Millstone Nuclear Power Station, Unit No. 3
Transmittal of a response to the SER Open Item (2)

Enclosed is Northeast Nuclear Energy Company's (NNECO) response to the SER open item (2) concerning the adequacy of the tornado-missile protection for the emergency diesel generator stacks. This response should fully resolve the staff's concern regarding the open item.

SER - 2 Diesel Generator (SER Section 3.5.2, 9.5.8)

Question Q430.134 (SRP Section 9.5.8)

FIG. 430.134-1

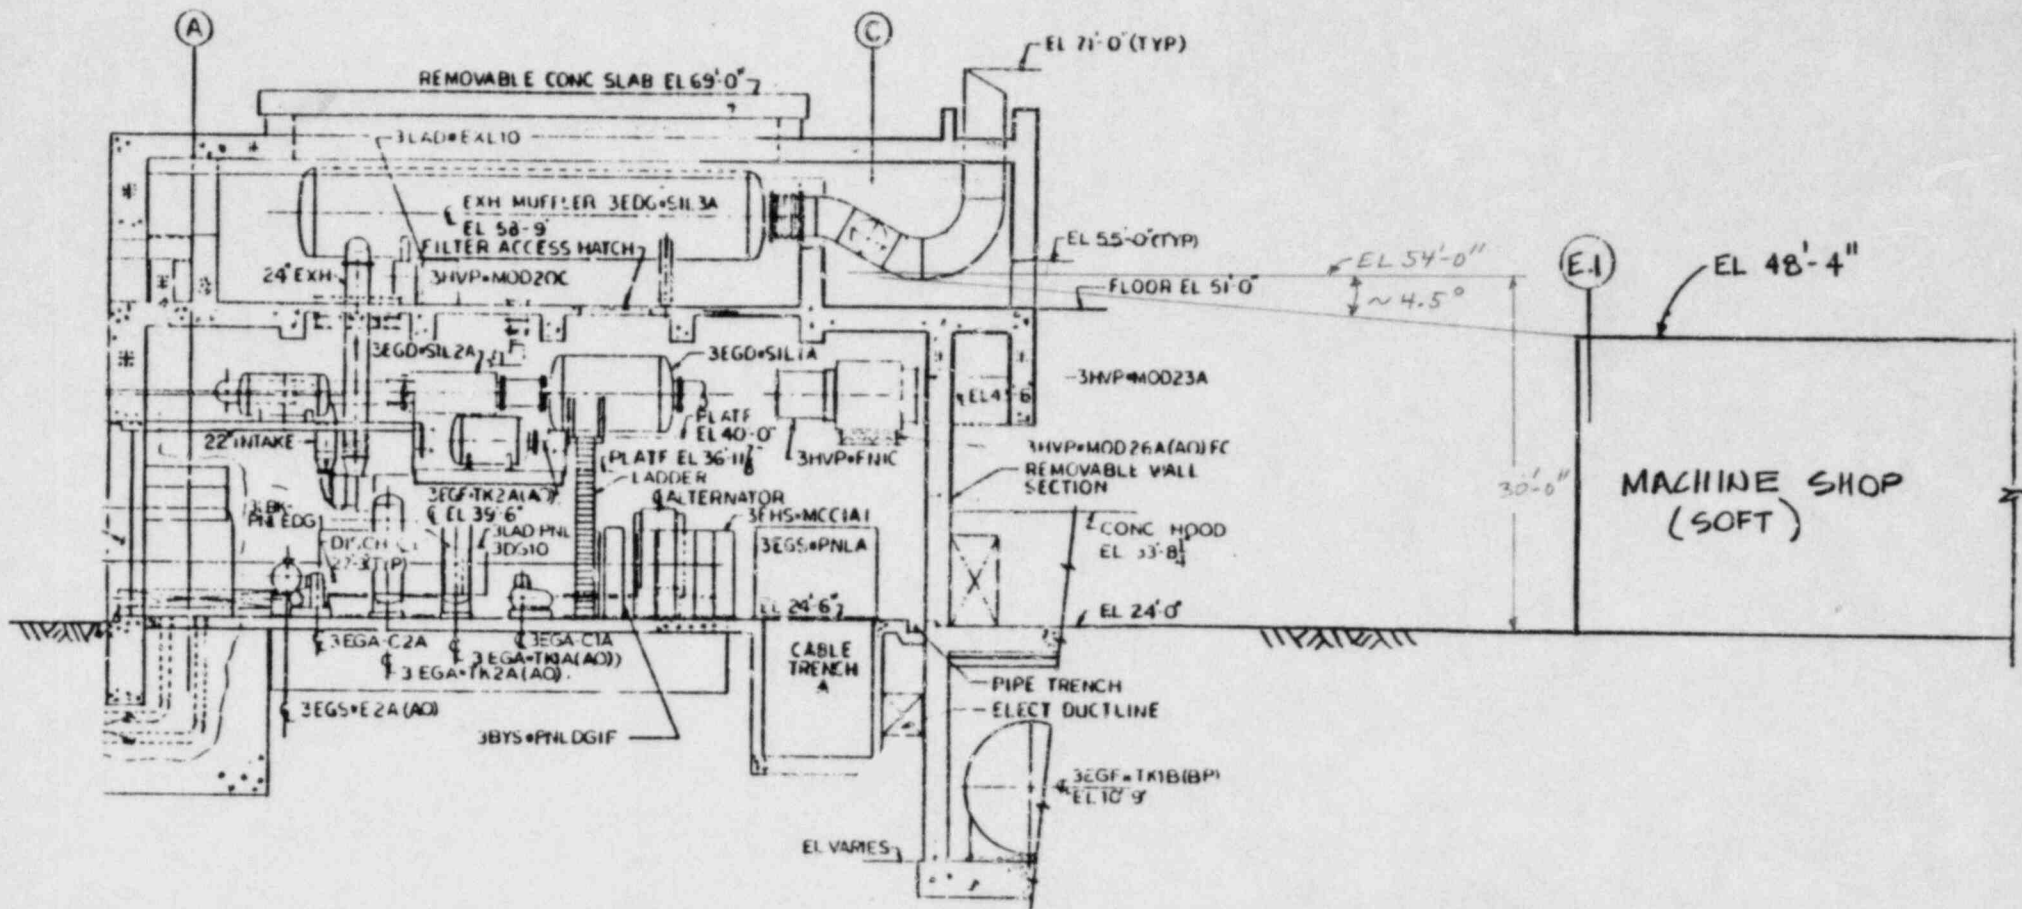
You state in Section 9.5.8.3 that damage to the exposed portions of the diesel exhaust pipe by tornado missiles has been considered. An access hatch in the exhaust ductwork, which will be manually opened during tornado alerts, functions as an exhaust bypass (secondary exhaust path) in the event of tornado missile damage to the exhaust system. This is an acceptable design. However, Figure 9.5.4 of the FSAR shows the location of the exhaust access hatch in relation to the exhaust ductwork and the exhaust plenum openings.

- a. From the drawings, a tornado missile, entering either the 66" x 100" or the 48" x 168" plenum openings, could cause sufficient damage to exhaust ductwork and the access hatch to degrade diesel generator operation or result in the unavailability of the diesel generators. We require that the exposed portions of the exhaust stacks be tornado missile protected. Comply with this position.
- b. In the event of freezing rain, ice storm, and/or a snow storm because of the location of the openings, clogging or total blockage, or the freezing shut of the access hatch could result. Describe the design features, inservice inspection procedures, and technical specifications which will preclude this event, or alter your design to address the concern.

- a. Damage to the access hatch from tornado missiles is not credible. Figures 430.134-1 and 430.134-2 show that no viable missile trajectory targets the access hatch. Once the access hatch is open, exposed portions of the exhaust ductwork are not required. Damage to these exposed parts will not degrade the exhaust.

The plenum openings are arranged in a manner which precludes the targeting of missiles on the exhaust duct access hatch. The exhaust duct is a 40 inch diameter pipe with a 3/8 inch wall thickness. It is seismically supported to withstand the high forces and accelerations experienced during a seismic event. The required missile trajectories necessary to cause damage to the exhaust stack coincident with the elevations required for missile damage are not credible. The proximity of adjacent buildings shields the engine's stack and further decreases the existence of a credible missile path.
